Proposal #06: 1060-27-71, WISC 2025596
I-94 East West, West Leg
70th Street to Zablocki Drive
IH 094
Milwaukee County

This is Addendum No. 03, which provides for the following:

ADDENDUM NO. 03

1060-27-71

WISDOT/CADOC SHEET 27

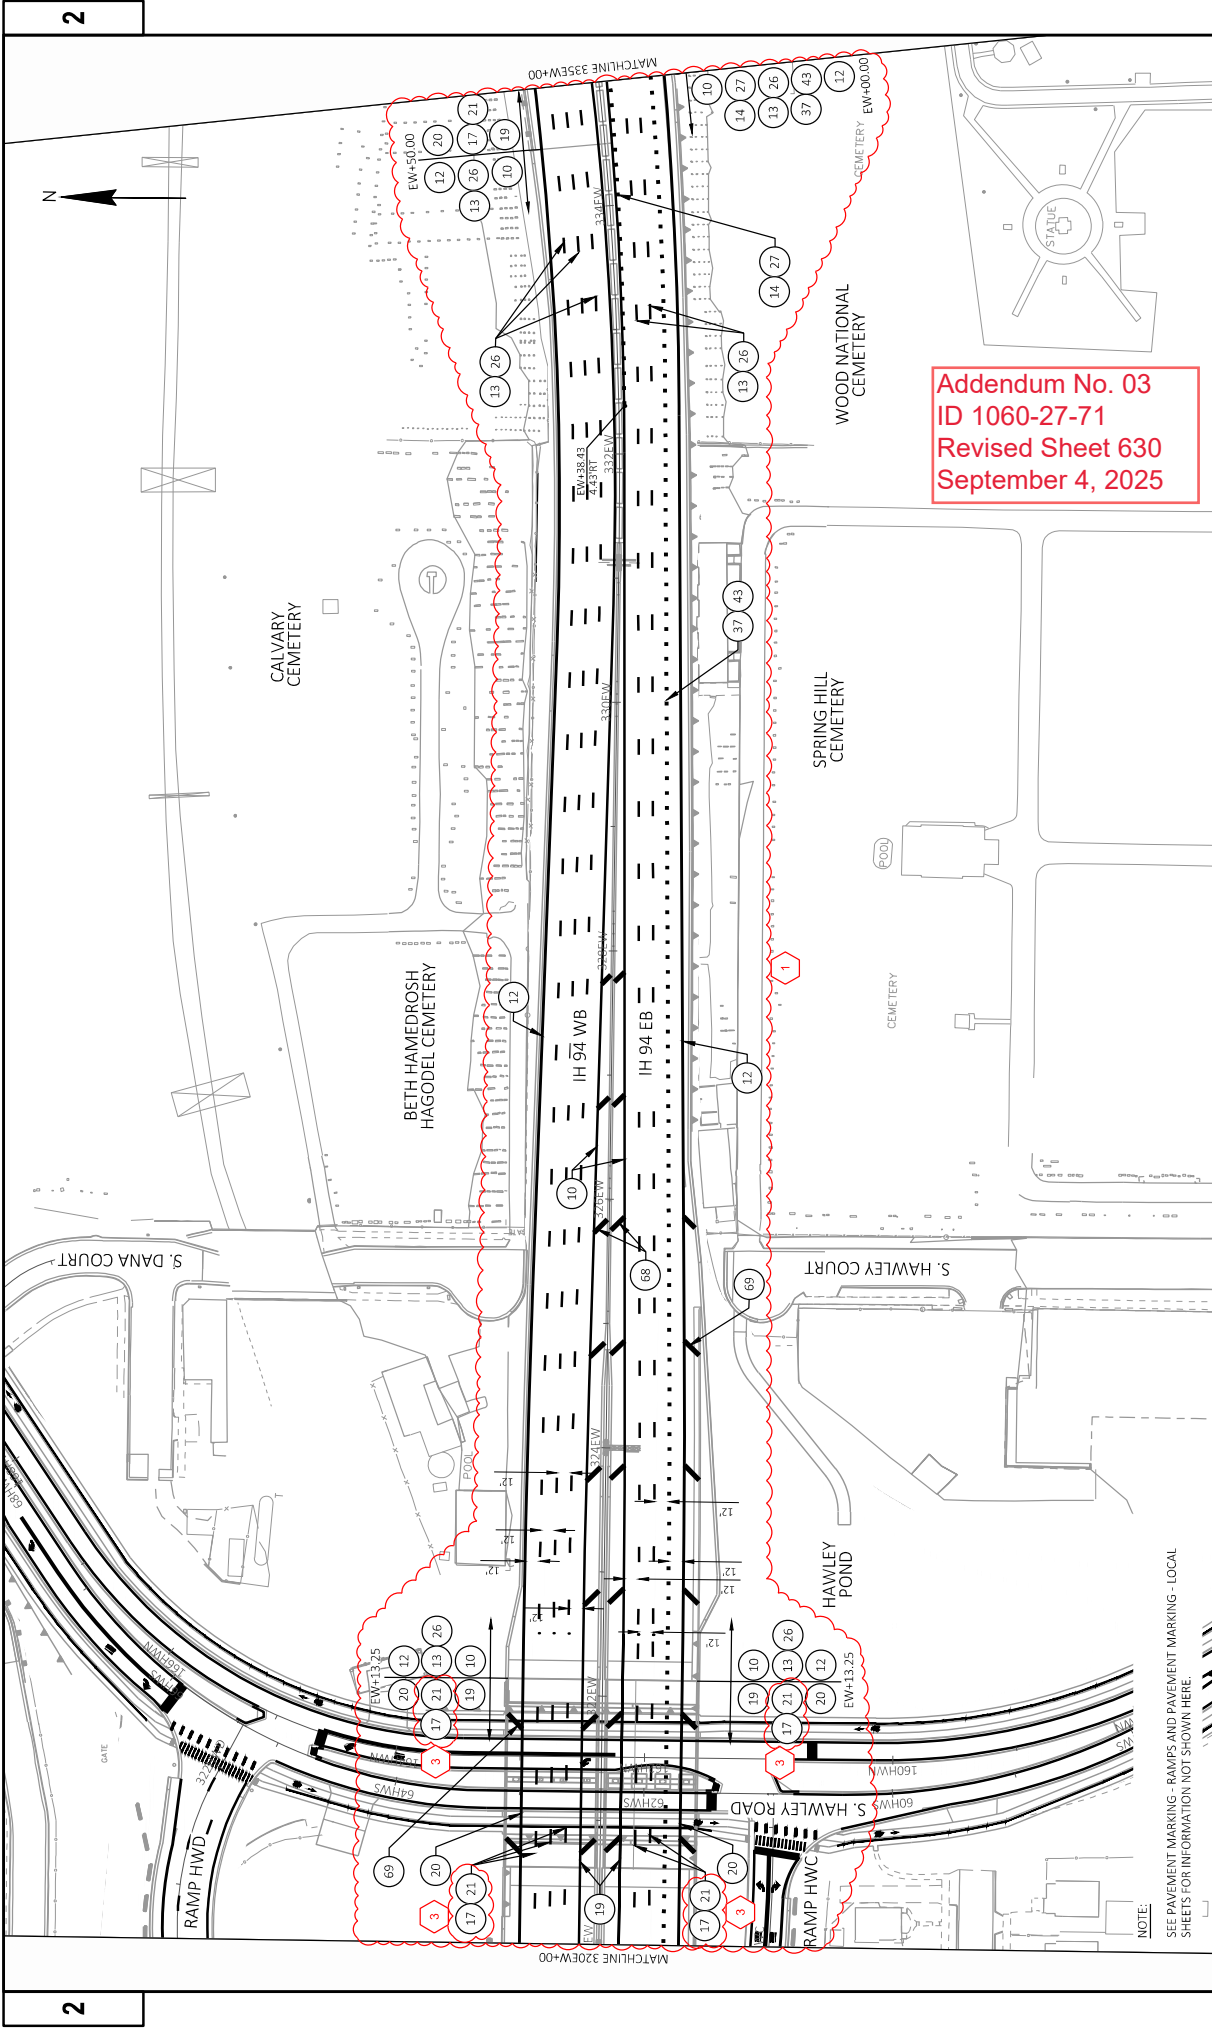
Revised Plan Sheets	
Plan Sheet	Plan Sheet Title (brief description of changes to sheet)
622-630	Pavement Marking: Changed all Permanent Tape markings to Wet Ref Epoxy
960-961	Miscellaneous Quantities: Changed all Permanent Tape markings to Wet Ref Epoxy
1166	Miscellaneous Quantities: Added table for open cut storm crossing pavement replacement
2110	R-40-741 General Plan & Elevation: Revised Note
2114	R-40-741 Anchor Slab Details: Revised Dimension
2115	R-40-741 Parapet Transition Detail: Revised Dimension
2120	R-40-742 General Plan & Elevation: Revised Note
2123	R-40-742 Anchor Slab Details: Revised Dimension
2143	R-40-762 General Plan & Elevation: Revised Note
2193	Monotube & 2-Chord General Data & Design Date: Quantity Updates for S-40-3111 & S-40-3114

Addendum No. 03
ID 1060-27-71
Revised Sheet 1166
September 4, 2025

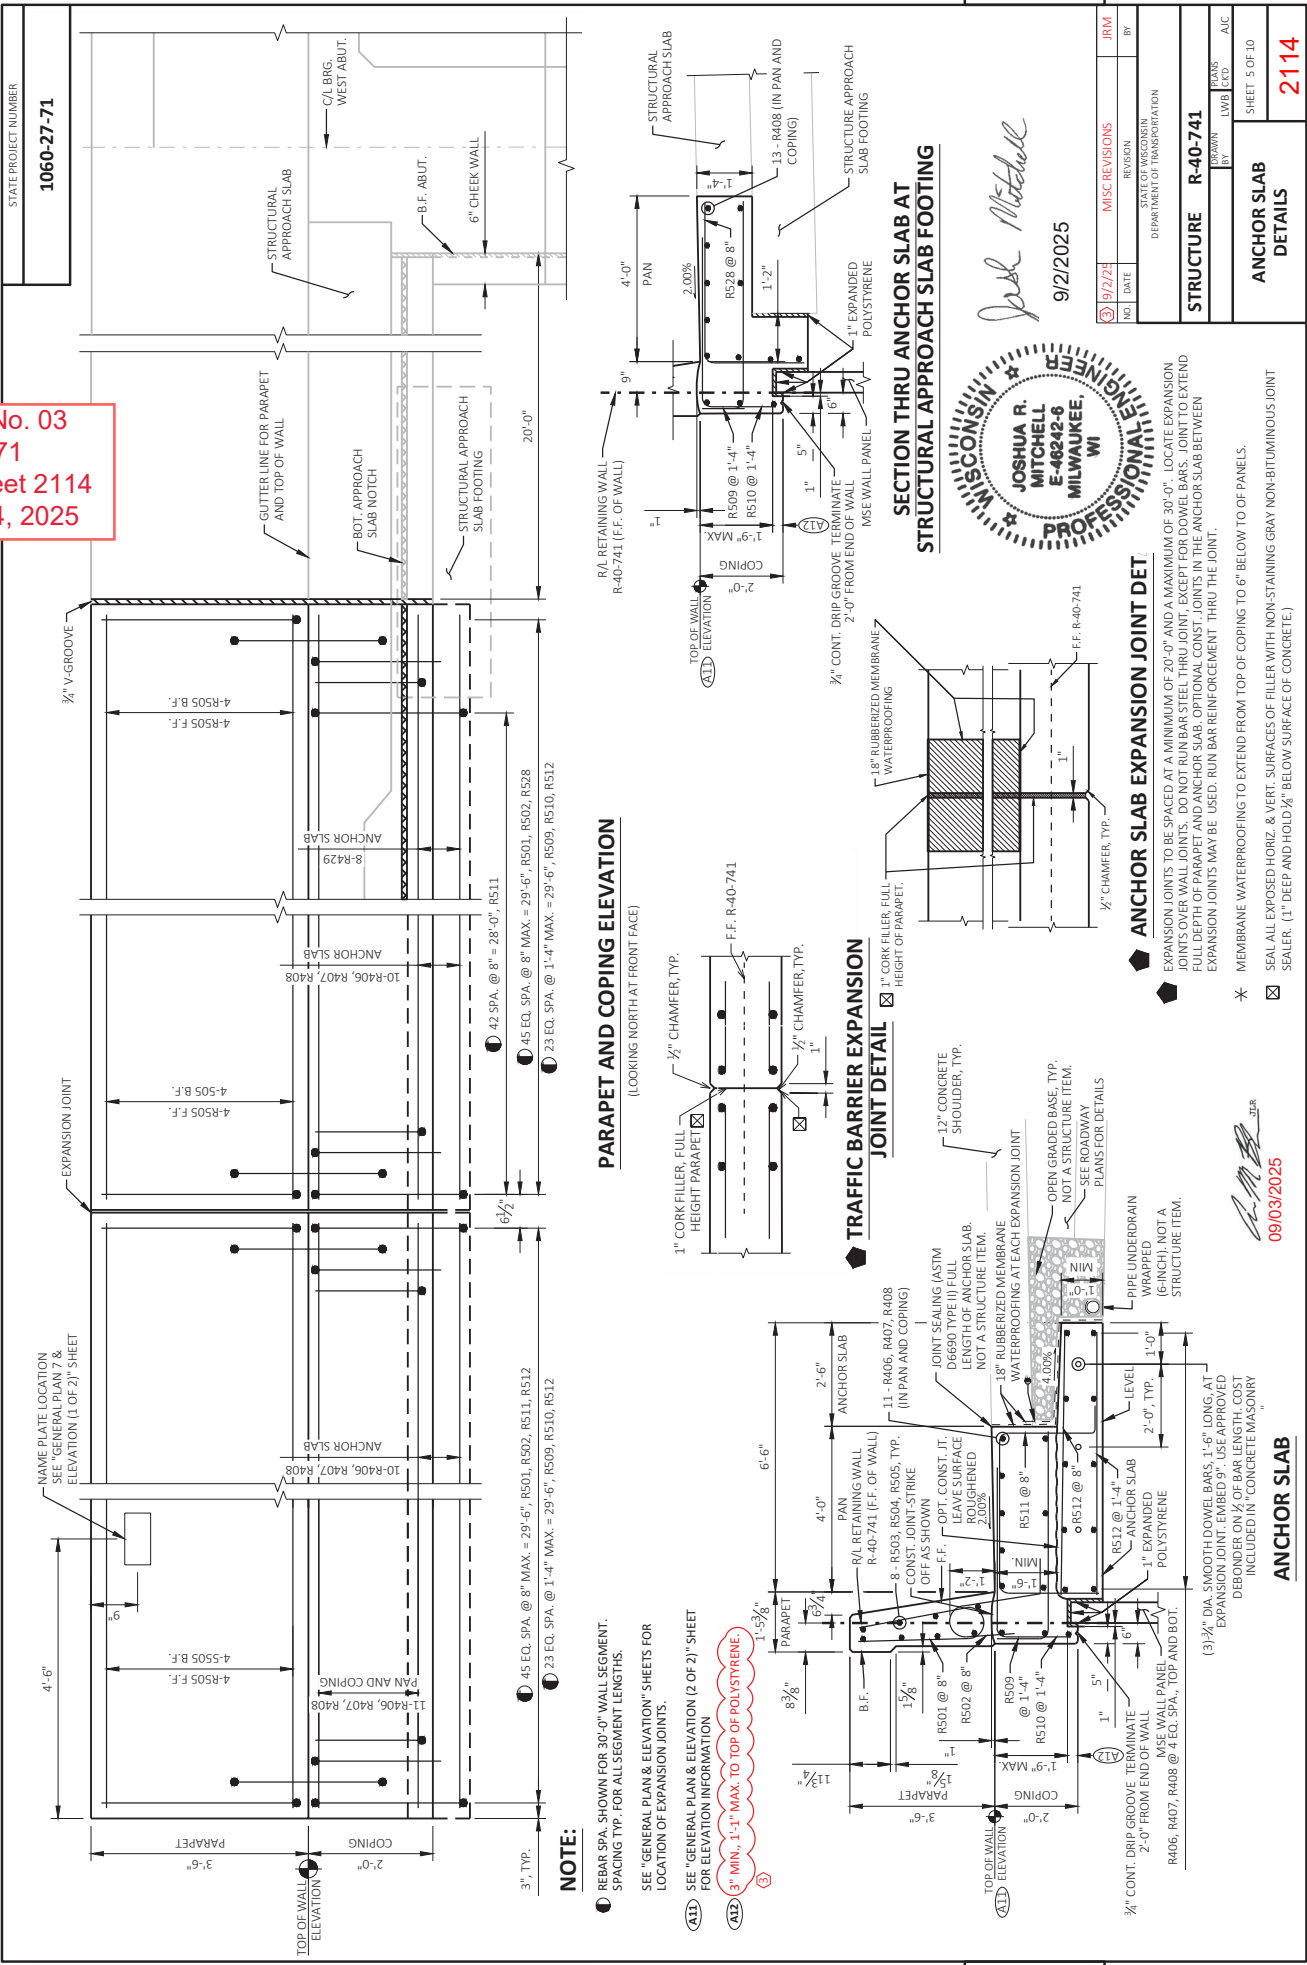
Revised Bid Item Quantities					
Bid Item	Item Description	Unit	Proposal Total Prior to Addendum	Proposal Quantity Change (-)	Proposal Total After Addendum
305.0120	Base Aggregate Dense 1 1/4-inch	TON	72,563	90	72,653
390.0100	Removing Pavement for Base Patching	CY	150	50	200
390.0405	Base Patching Concrete SHES	CY	150	50	200
531.2030	Drilling Shaft 30-Inch	LF	116	-52	64
